Hadley Smart Valve – Raising Suspension – Update

Hadley Smart Valve causing rear suspension ride height to inflate to max

4th Generation Cascadia

Fig. 1, Hadley SmartValve

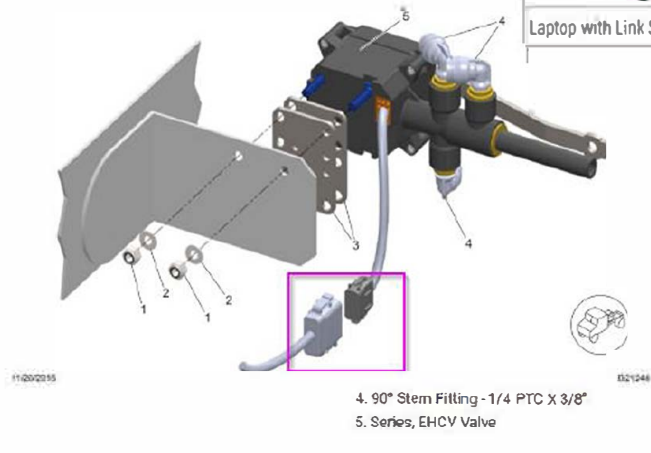
Software bug causing unintended raised suspension while in bobtail mode

Current Field Fix: Replace valve with latest p/n **OR** Laptop + CAN cable firmware to locations w/ highest concentration of trucks (via connection @ highlighted)

Production Changeover Date: December 2025 (any parts received now are the latest version)
